## Product Change Notice (PCN)

**Subject:** Assembly materials change for R8C/L3x LFQFP 100pin package products

# Difference of specification (R8C/L3Ax LFQFP 100pin)

MCP-AB-22-0133

# Material change items

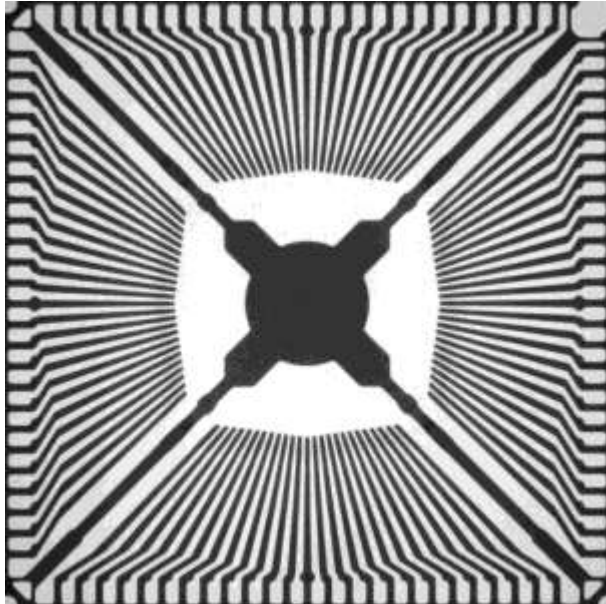
| Item       |          | Before change                     | After change                           |
|------------|----------|-----------------------------------|----------------------------------------|
| Mold resin | Material | Epoxy resin A *<br>(halogen-free) | Epoxy resin A or B *<br>(halogen-free) |

\* Although there are material changes, the combination after the change has a track record of mass production, and there is no change in reliability and characteristics.

# Lead frame shape

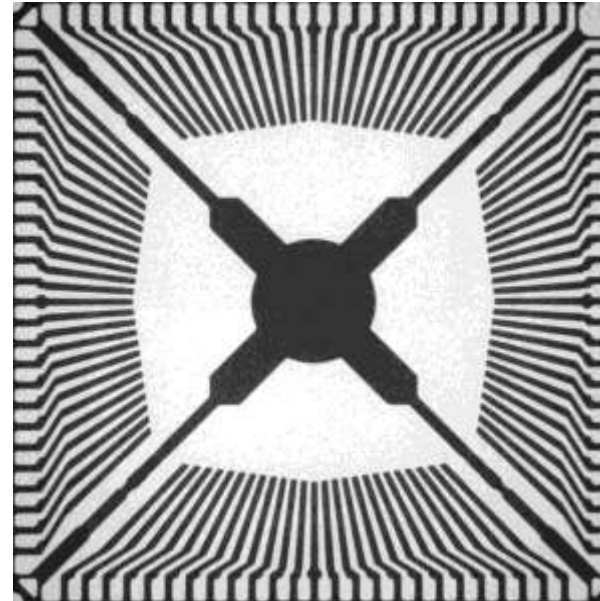
14×14mm 0.5mm pitch 100pin LFQFP lead frame

Consolidate into certified and proven lead frames.

Before change: “**Frame A**”

After change “**Frame C**”
